HTA-700B v.2 tubes upgrade

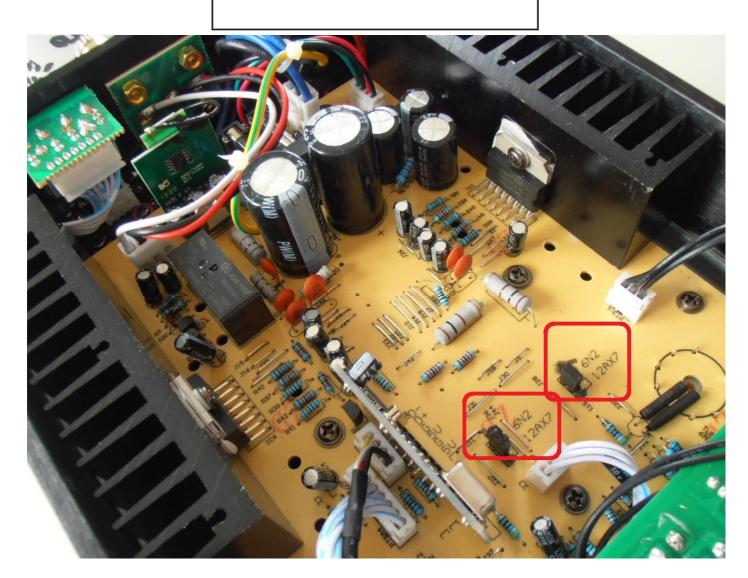
- 1. Switch off the unit and disconnect the power cord;
- 2. Disconnect all connected devices and speakers;
- 3. Place the amplifier upside down on the flat surface;
- 4. Unscrew screws located on the bottom of the amplifier and remove the bottom cover;
- 5. There are two 3-pin jumper blocks located on the main board (marked 6N2 12AX7);
- 6. Remove the jumper shunt in each block and place is in the position marked 12AX7;
- 7. Screw in the bottom cover;
- 8. Exchange tubes to 12AX7 type;
- 9. Your amplifier is ready for operation.
